ADDENDUM NO. 2

PROJECT: Central Arkansas Water
Ozark Point Water Treatment Plant
Lime and ZOP Improvements
Little Rock, Arkansas

CRIST ENGINEERS PROJECT NO. 24045
CENTRAL ARKANSAS WATER
OZARK POINT WATER TREATMENT PLANT
LIME AND ZOP IMPROVEMENTS
RESPONSE TO QUESTIONS

JOB NO.	24045
SHEET NO.	C-4

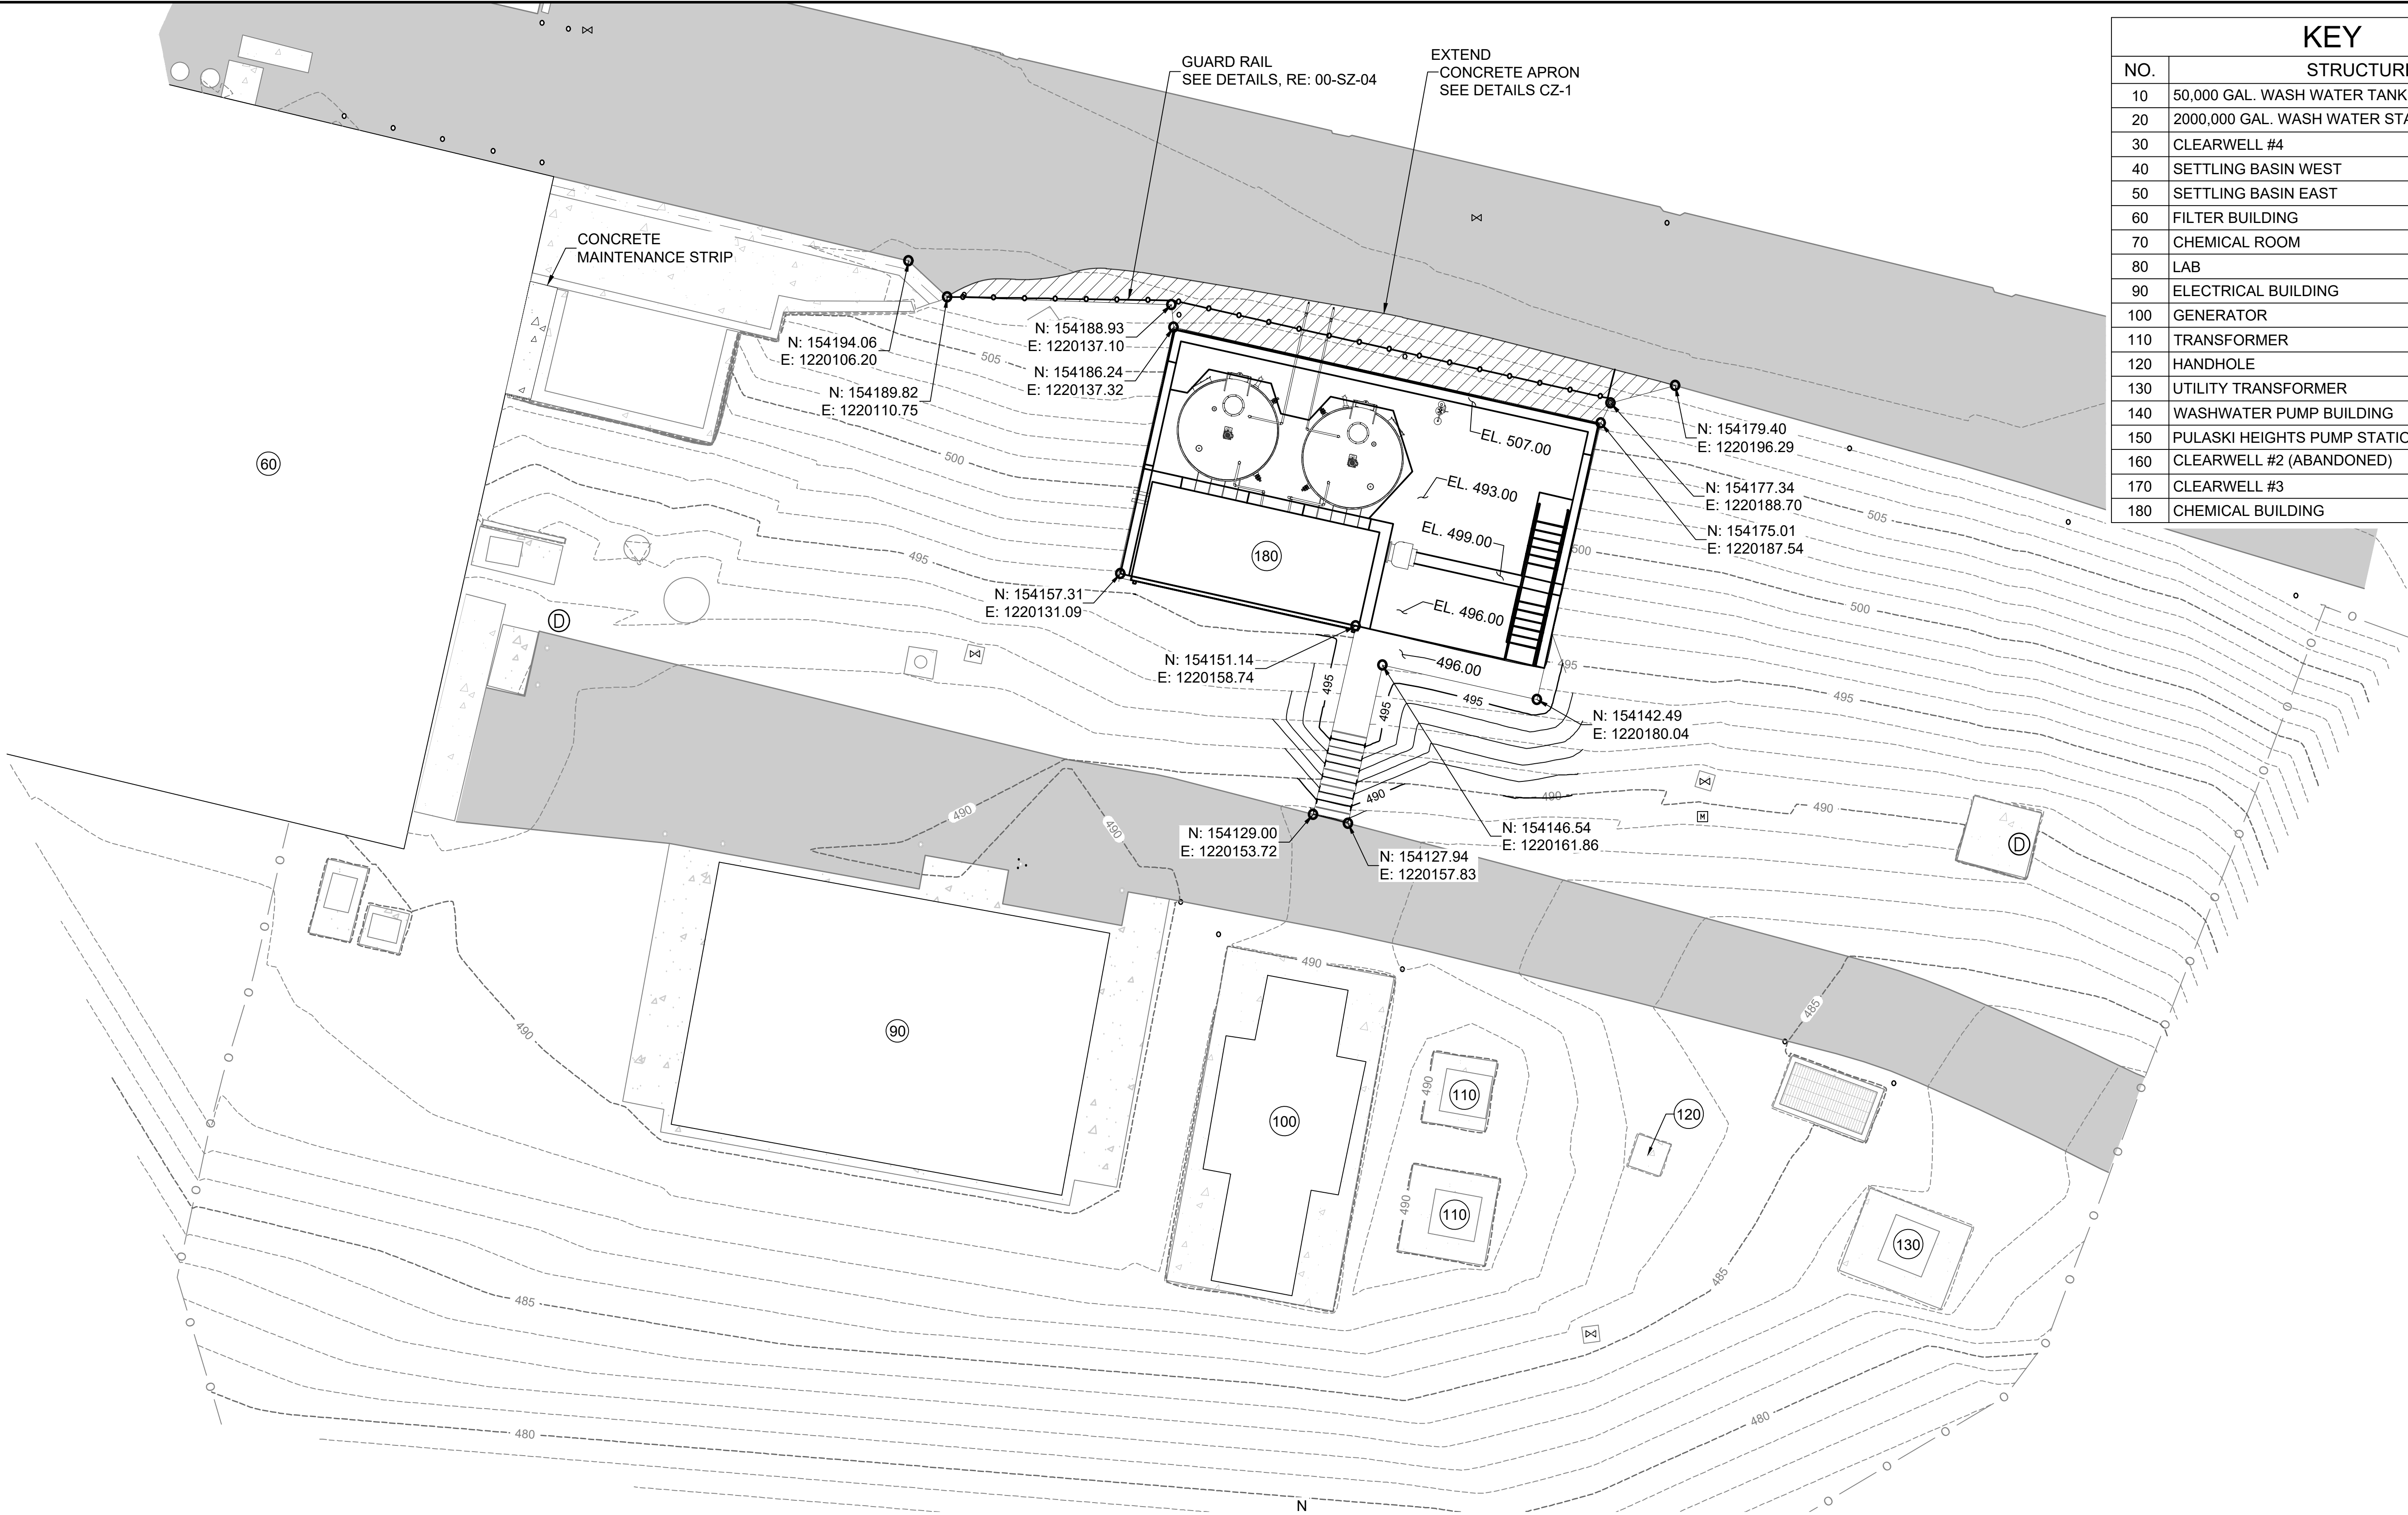
Item No. 4. Sheet C-04

- a. Attachment 4 is the new issued Sheet C04

12	Please confirm integration of the new chem feed systems into existing SCADA is to be completed by Owner.	Tolm Group (TR)	SCADA Integration will be performed by the owner.
13	Is the use of vibration equipment and sheet piles allowed for shoring of the excavations required for the new Lime Chem Buiding?	Tolm Group (TR)	Contractor assumes liability for any and all construction methods they utilize for the outlined project.
14	If vibration equipment/sheet piles are not allowed, is there an alternative laydown area? Access (the existing road) to the planned laydown area will likely be lost if excavations of the new lime chem building are sloped at a minimum 1:1.	Tolm Group (TR)	Primary laydown will be as established within the plans and specifications. Any additional laydown area will be designated by the owner on a conditional basis.
15	C-4 shows a Guard Rail with the reference to MZ-05. The documentation does not include a plan sheet MZ-05. Please provide details for this Guard Rail.	Tolm Group (TR)	Callout has been changed to 00-SZ-04, See new Sheet C-04
